2016 Amendments to Chapter 14 Subdivision Regulations

33. Sec. 14-6-8: Added Figure 6-17.

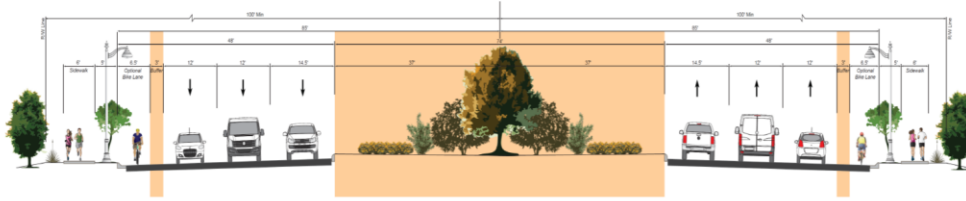
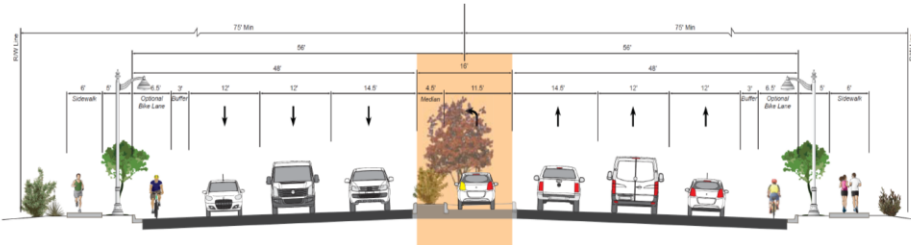
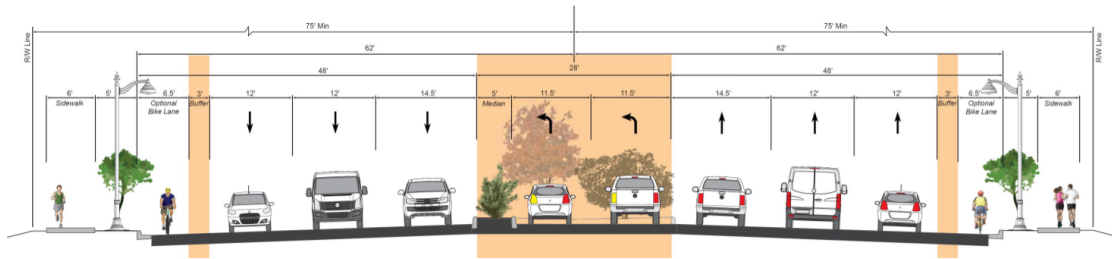
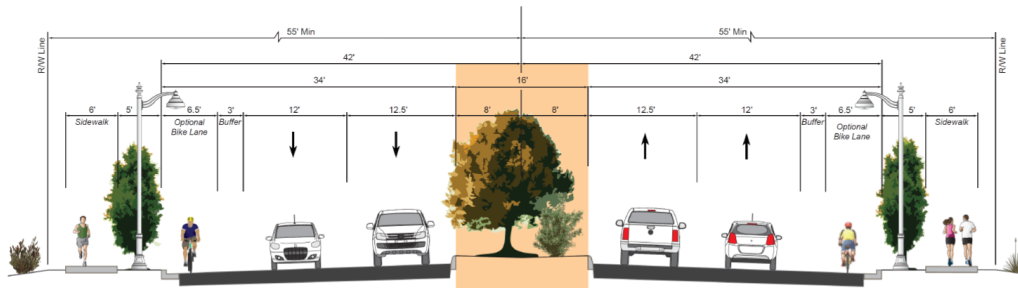
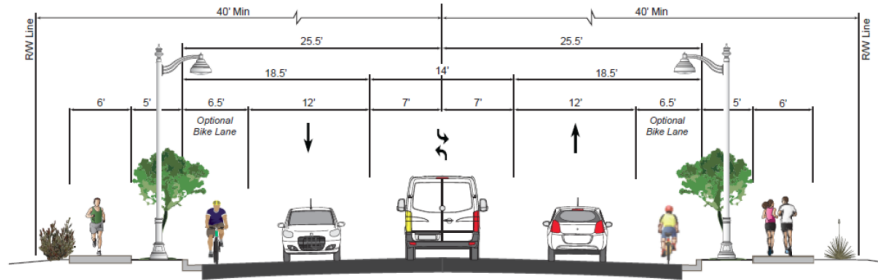
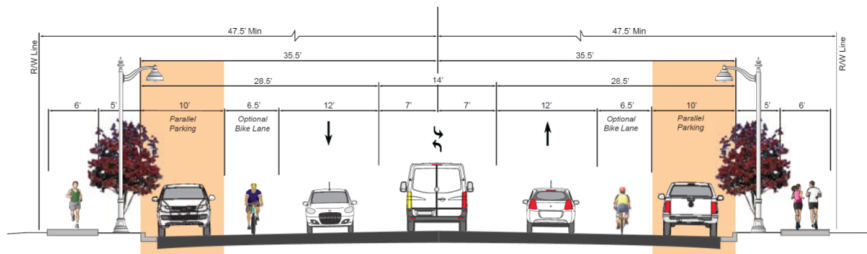
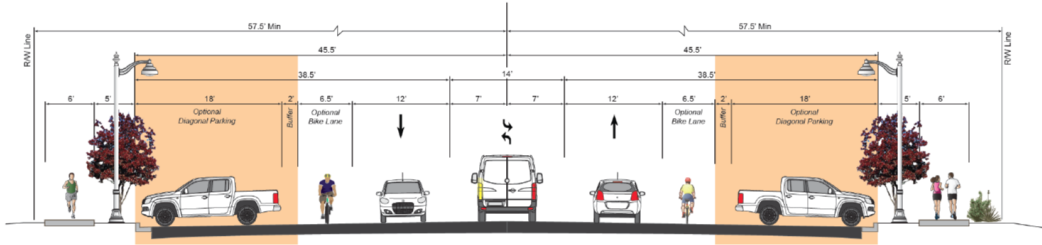
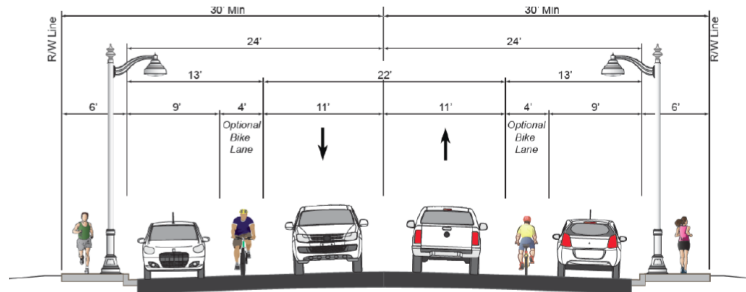
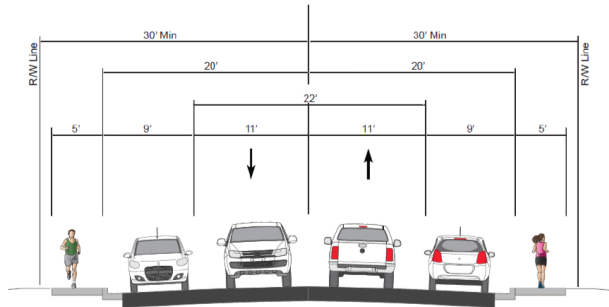
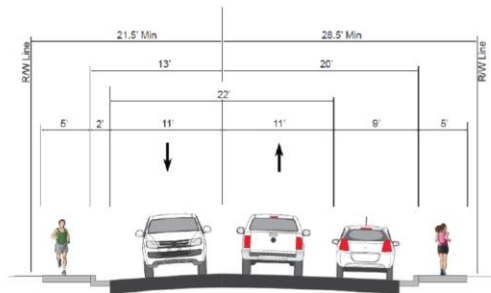
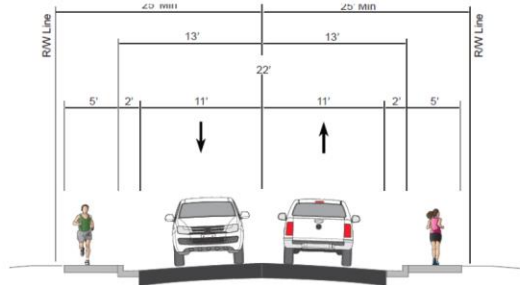
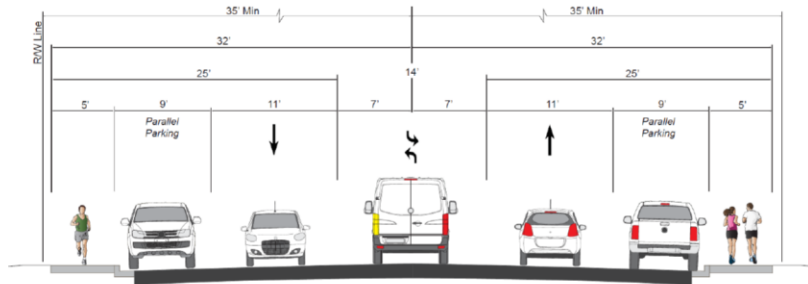
29. Sec. 14-6-8 (table 3): added the following table (see below).
